S.I. No. M20-38

SERVICE INSTRUCTION

SUBJECT: REPLACEMENT OF INSTRUMENT LIGHT
CONTROL ASSY

AFFECTED: M20C, Serial Numbers 20-1186 thru 20-1226
M20F, Serial Numbers 22-1246, 22-1306 thru 22-1435
M20J, Serial Numbers 24-0001 thru 24-0070

FIGURE #2 (J MODEL)

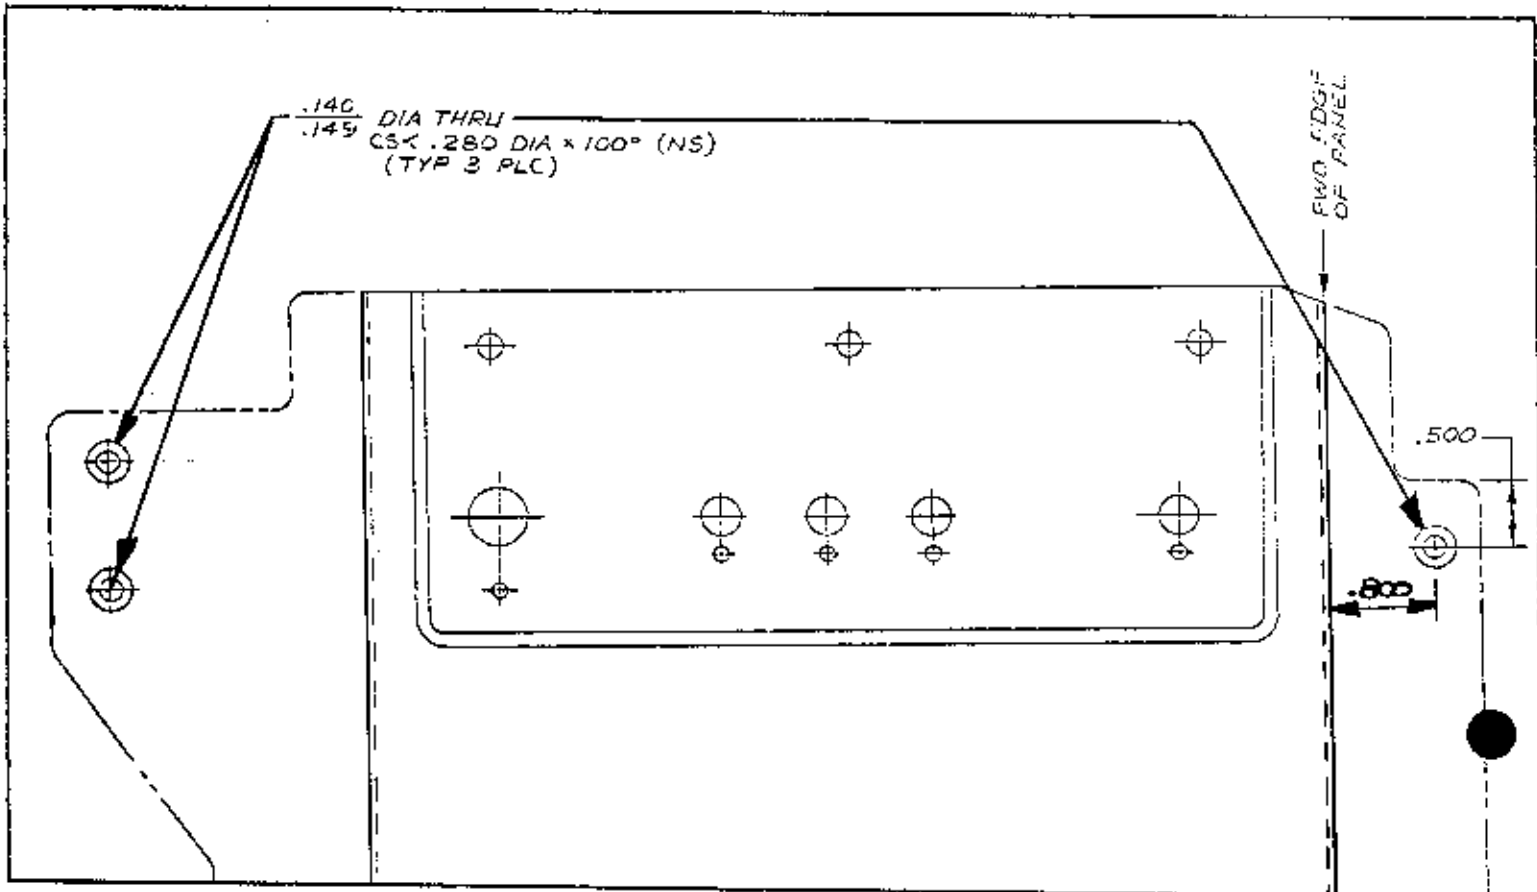
3. Disconnect plug and knife disconnect from rheostat and transistor bracket.
4. Remove light control knob and nut attaching rheostat to radio panel.
5. On aircraft S/N 24-0001 thru 24-0040, drill out (2) existing rivets and remove transistor bracket. Drill out and countersink (2) existing holes and add (1) countersunk hole per Figure #2.

6. On aircraft S/N 24-0041 thru 24-0070 remove (2) screws holding transistor bracket to radio panel and add (1) countersunk hole per Figure #2.
7. Install light control assy (800331-927) with (3) AN507-632R5 screws and reinstall rheostat and knob in radio panel per Figure #4.
